AMENDMENTS TO THE DRAWINGS

Application No.: 09/885,688

Docket No.: F1866.0062

FIG. 11

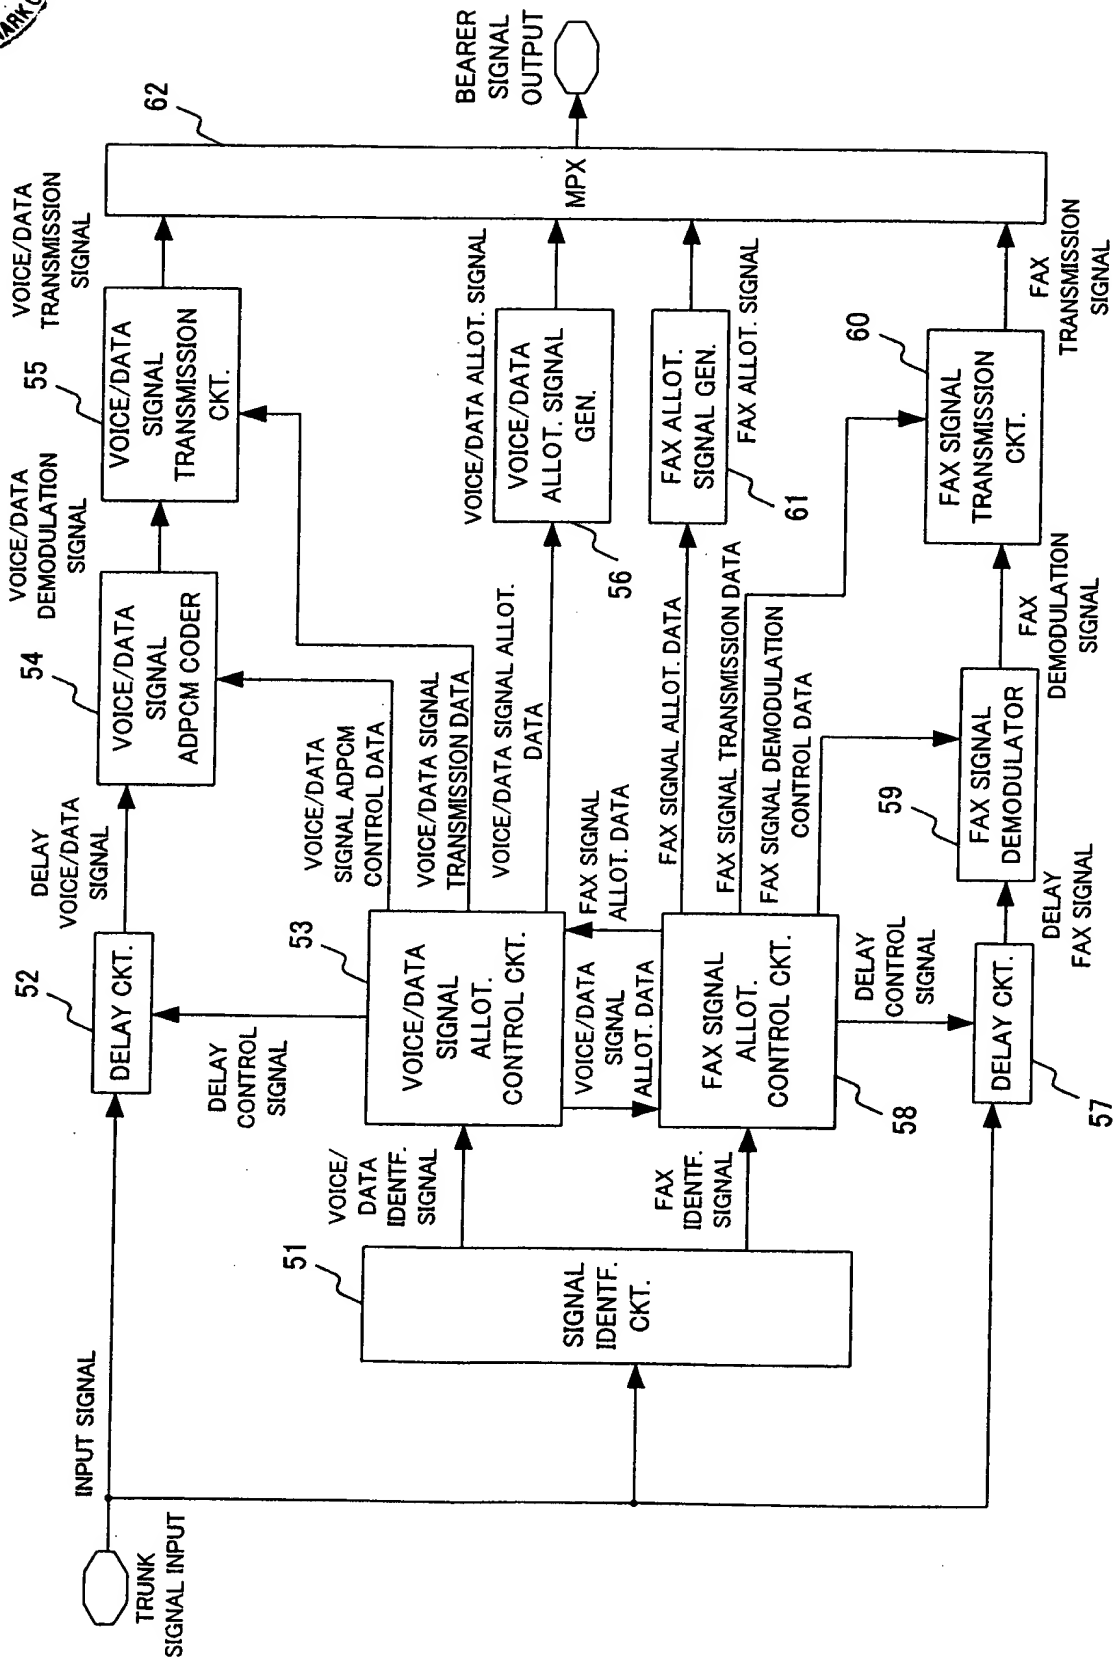
The attached sheets of drawings include changes to Figures 11 and 12 which have been amended to add the designation “Prior Art” in accordance with 37 C.F.R. § 1.121(d). Figure 12 has further been amended to correct typographical errors contained therein.

Figures 11 and 12 have been objected to under 37 C.F.R. § 1.121(d) for not being designated by a legend --Prior Art-- . Figure 12 has been objected to under 37 C.F.R. § 1.84(p)(5) because it includes a reference character not mentioned in the description. Claims 1-12 are pending and have been examined in the present application. Claims 1-12 have been rejected under 35 U.S.C. § 103(a) over the admitted prior art. Reconsideration of the present application is respectfully requested in light of the below remarks.

Figures 11 and 12 have been corrected to include the designation "Prior Art." Figure 12 has been amended to exclude the "FAX control signal" reference. The inclusion of this reference character in Figure 12 was due to a typographical error. Its exclusion does not add new matter to the application. Withdrawal of the objection is therefore respectfully requested.
